ITEM: 6.14	COMMITTEE OF ADJUSTMENT REPORT SUMMARY MINOR VARIANCE APPLICATION FILE NUMBER A315/22 98 DORENGATE DRIVE, WOODBRIDGE
-------------------	---

**COMMITTEE OF ADJUSTMENT REPORT
MINOR VARIANCE APPLICATION
A315/22
98 DORENGATE DRIVE, WOODBRIDGE**

ITEM NUMBER: 6.14	CITY WARD #: 2
APPLICANT:	Nino Montagnese & Peter Salituro
AGENT:	None
PROPERTY:	98 Dorengate Drive, Woodbridge
ZONING DESIGNATION:	See Below
VAUGHAN OFFICIAL PLAN (2010) DESIGNATION:	Vaughan Official Plan 2010 ('VOP 2010'): "Low-Rise Residential"
RELATED DEVELOPMENT APPLICATIONS:	None
PURPOSE OF APPLICATION:	Relief from the Zoning By-law is being requested to permit an existing swimming pool, storage shed and reduced landscaping requirements in the rear yard.

PROJECT:
EXISTING TOPOGRAPHIC PLAN
98 DORENGATE DRIVE
WOODBIDGE, ON., L4L 1M6

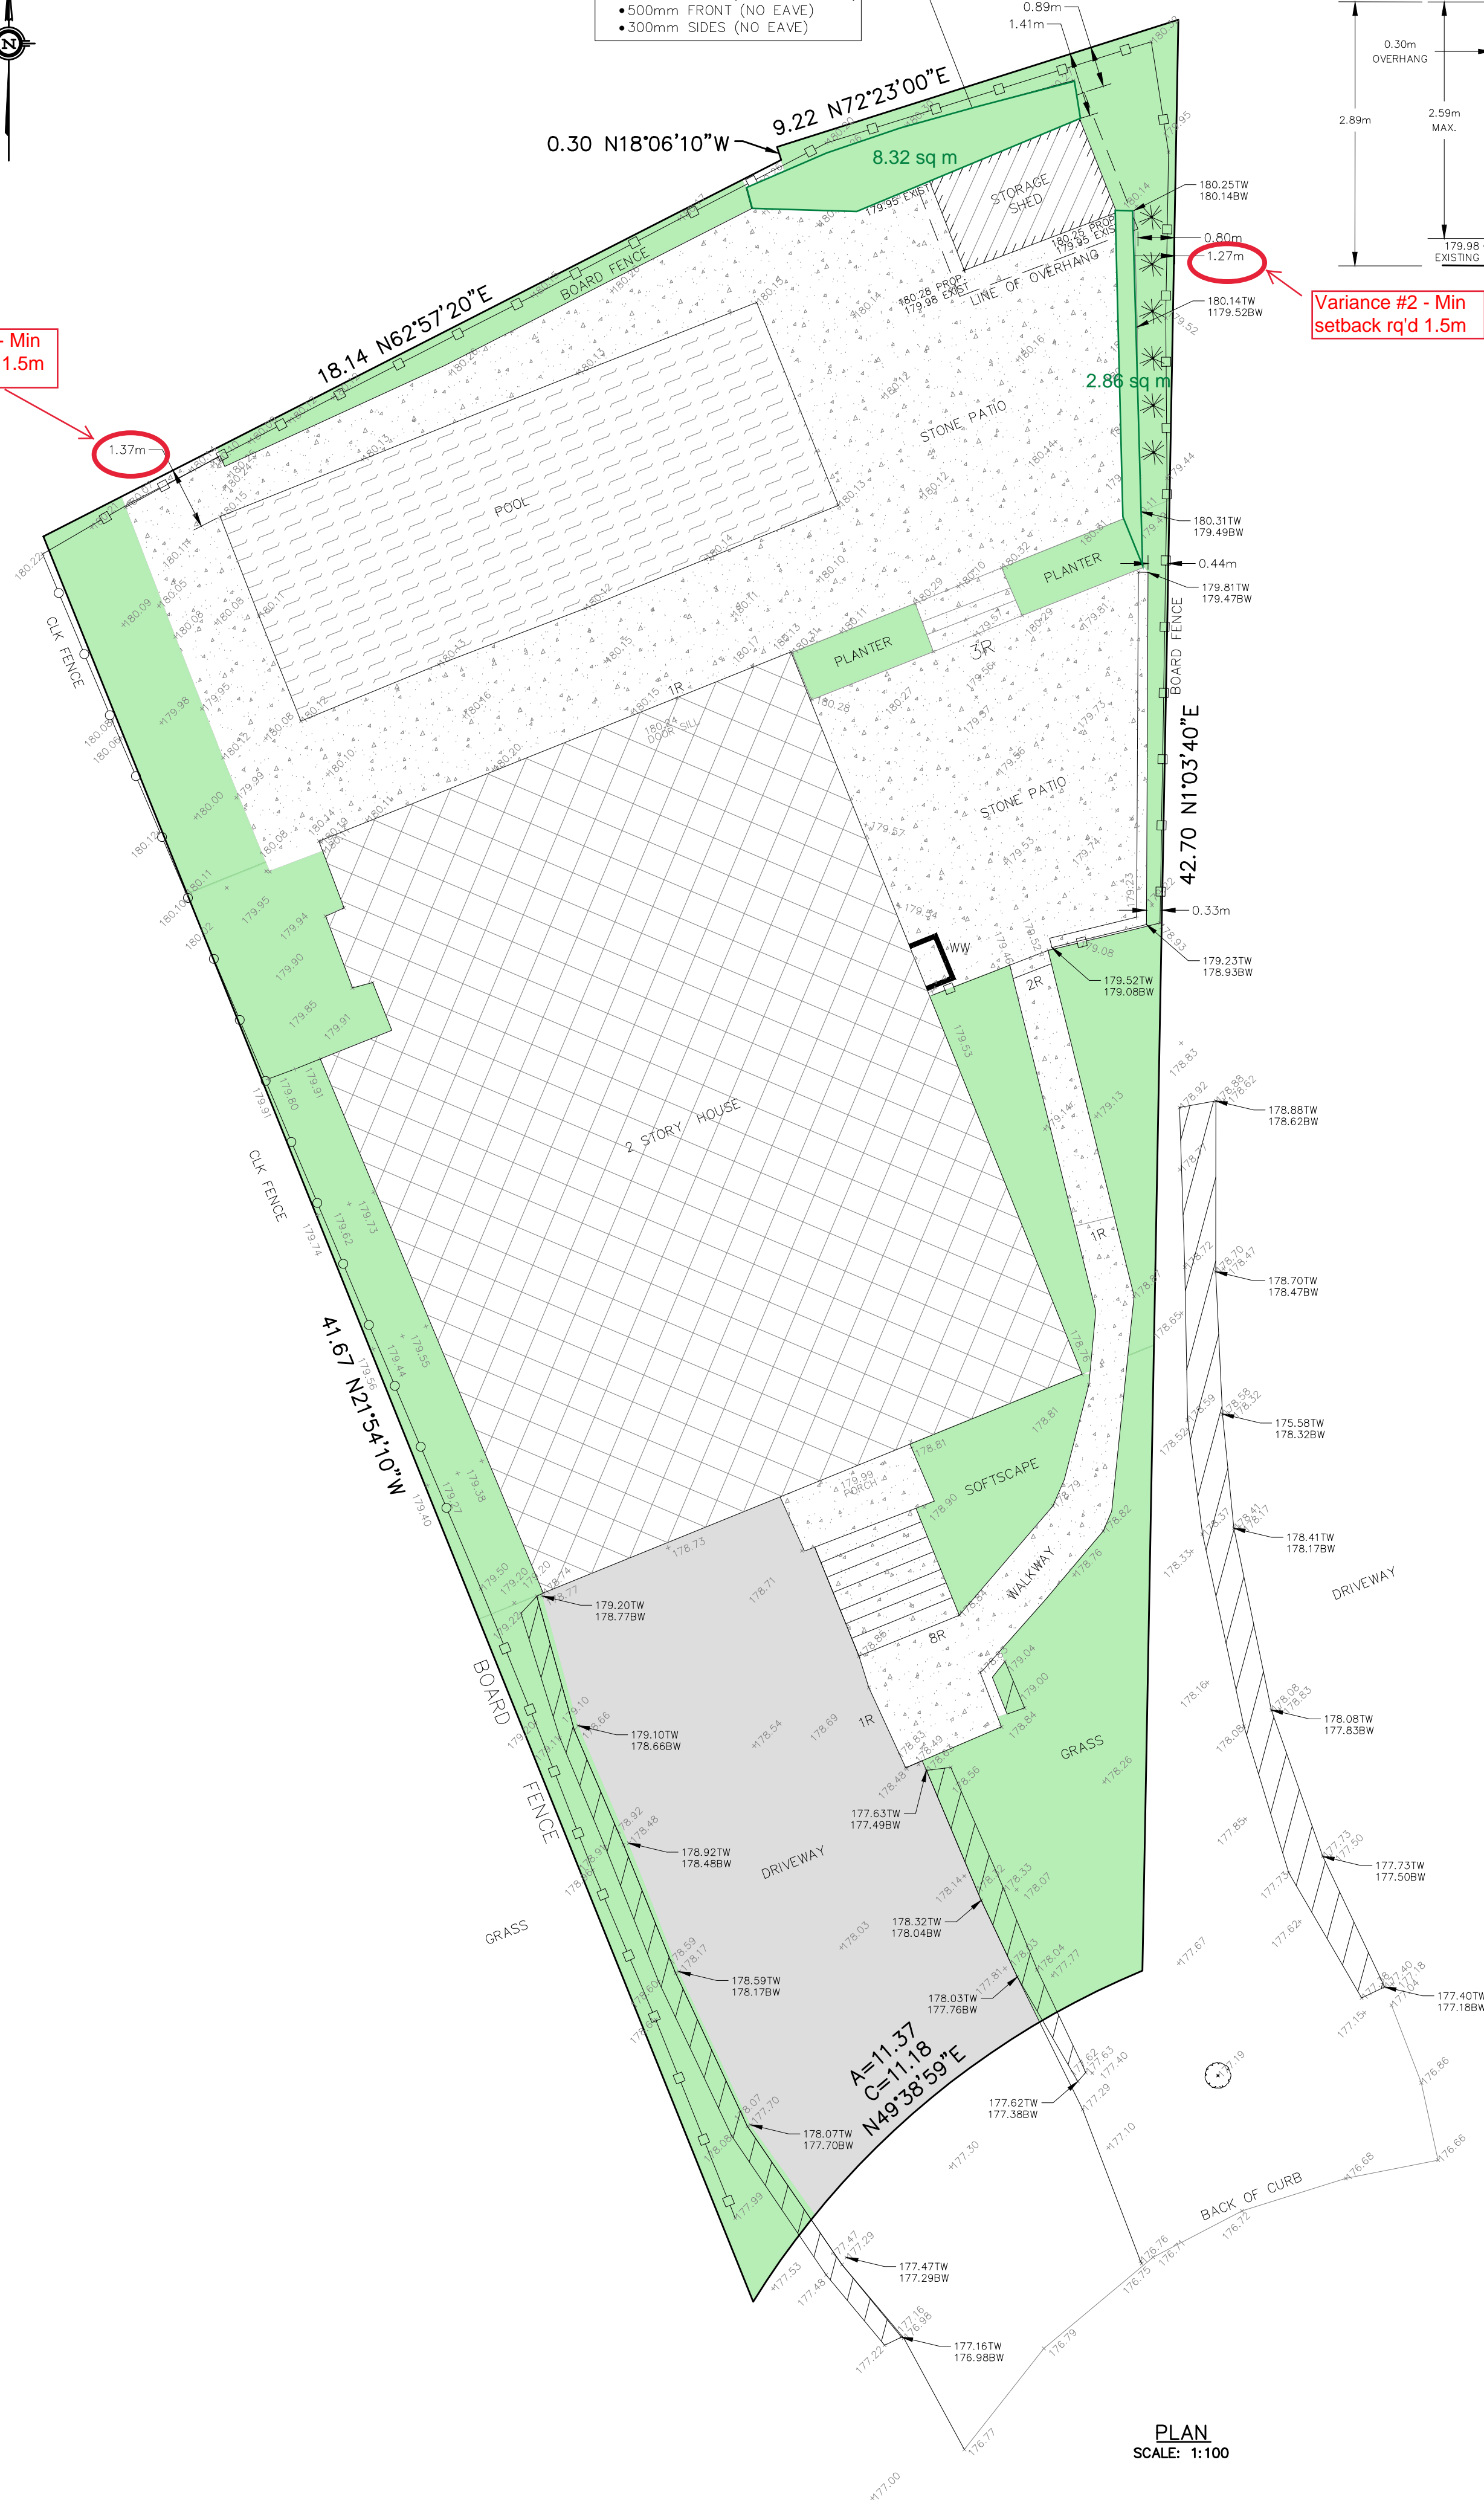
Variance #1 - Min
Setback req'd 1.5m

Variance #2 - Min
setback req'd 1.5m

Variance #3
